Groundwater and Wastewater Services File Imaging Project

Groundwater & Wastewater Services
Septic Project File & Data Review Worksheet

RE: Request for an Improvement Permit for Lot 3 off of Sample Road.
MCHD File #6741B

SEPTIC SYSTEM DESIGN REVIEW WORKSHEET

Scale: 1 inch equals 50 feet	S&ME	Faison-Sample Road, LLC	FIGURE
Drawn by: JBP		Lot 3	
Reviewed by: Jeremy P. Michelone, RS		Mecklenburg County, NC	1
Date: February, 2007	ENVIRONMENTAL SERVICES • ENGINEERING • TESTING	S&ME Project #1588-05-091

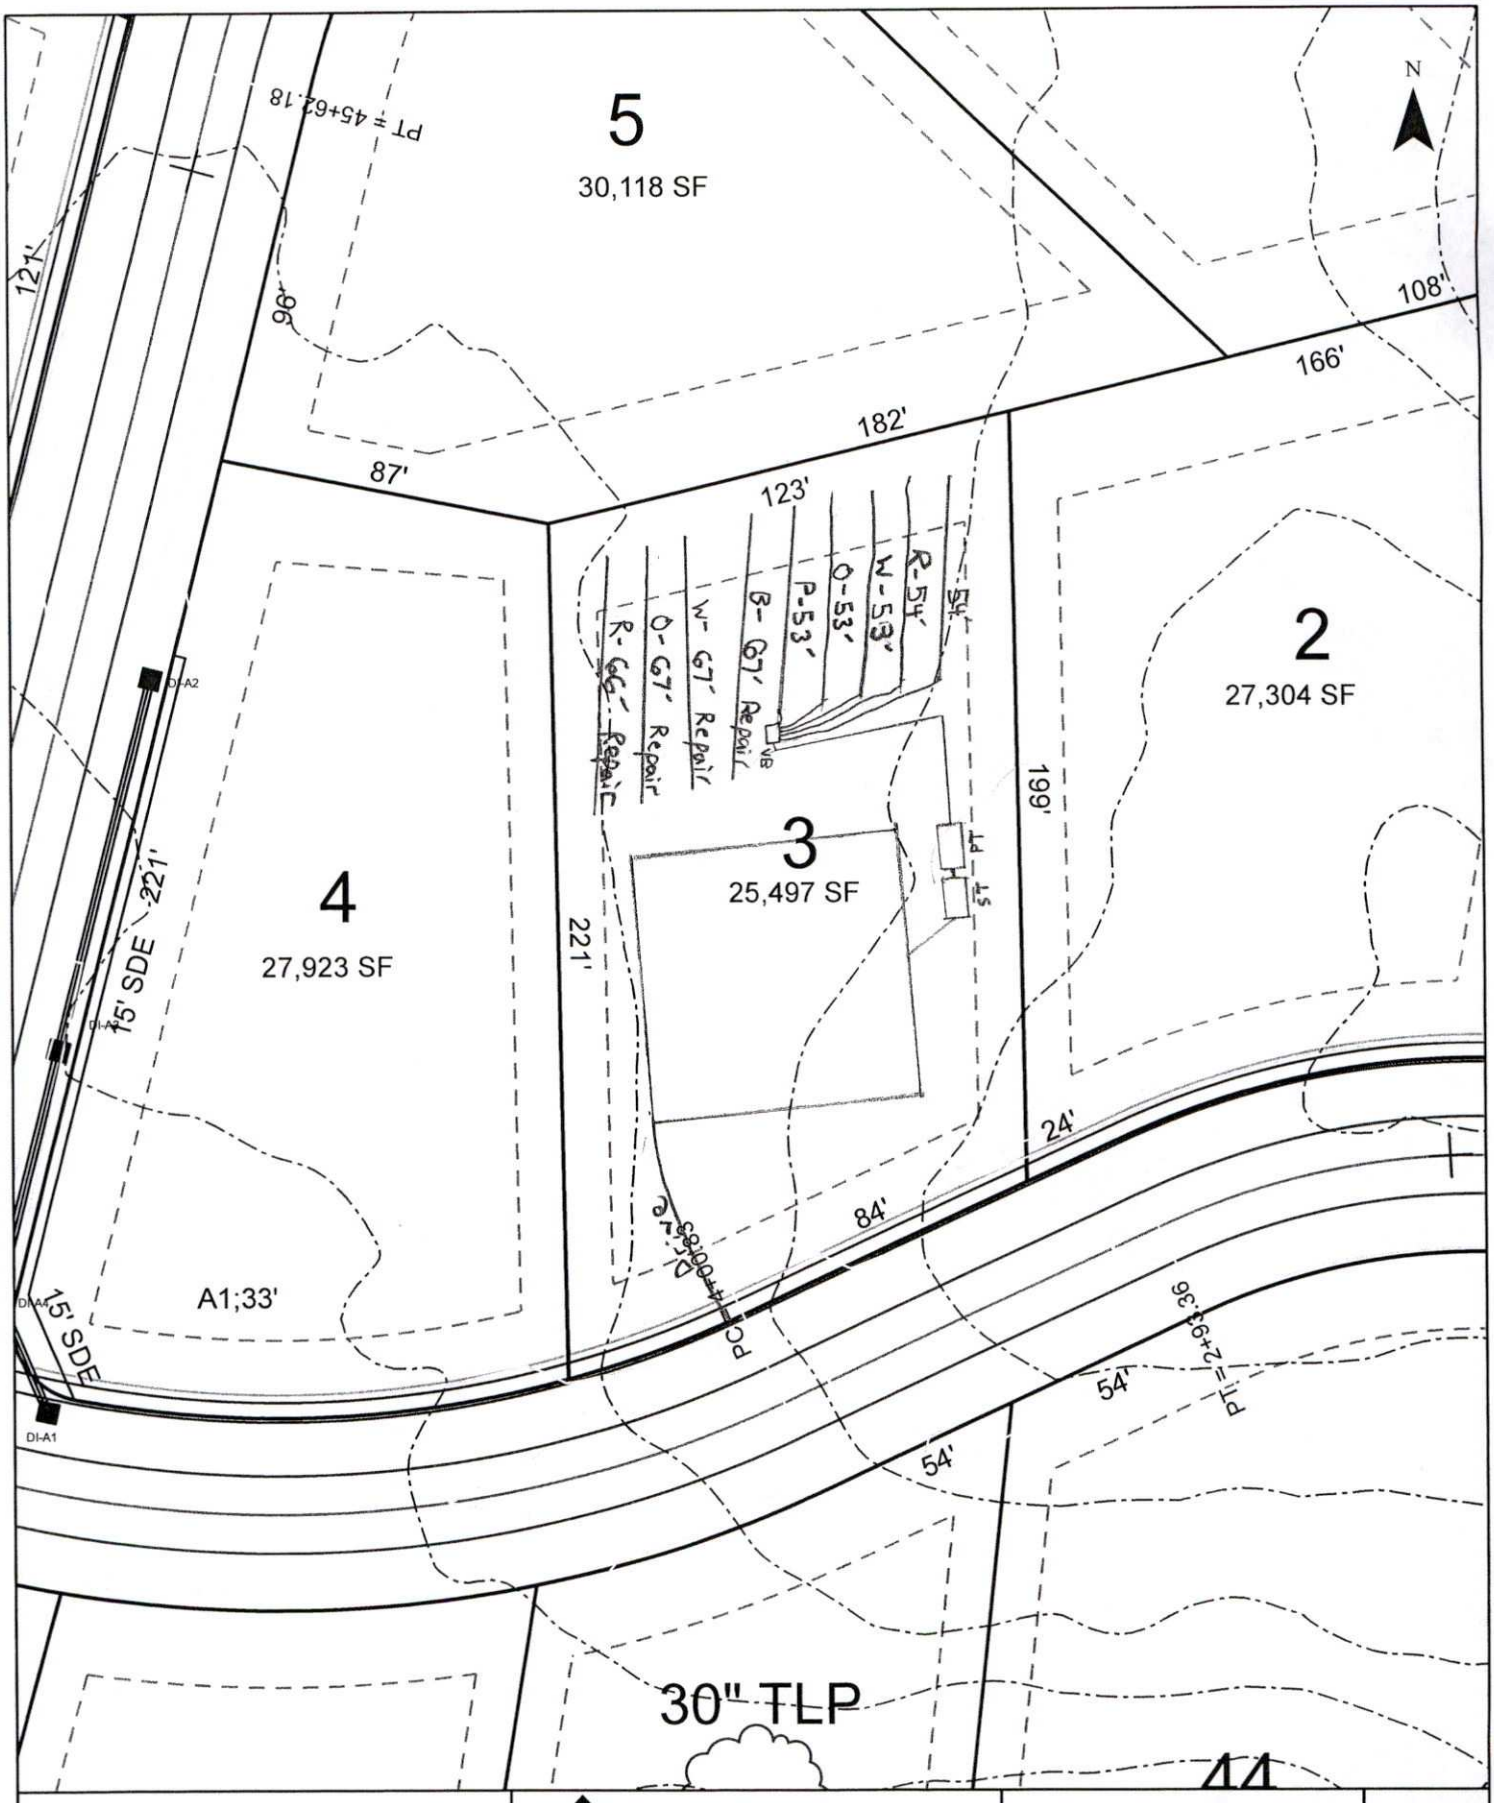
1. No Modified Plot Plan application on file for project. Need application & fees. Must enter into WASPS for permitting.
2. Soil report needs to be updated to show type IVa system for Initial System Type.
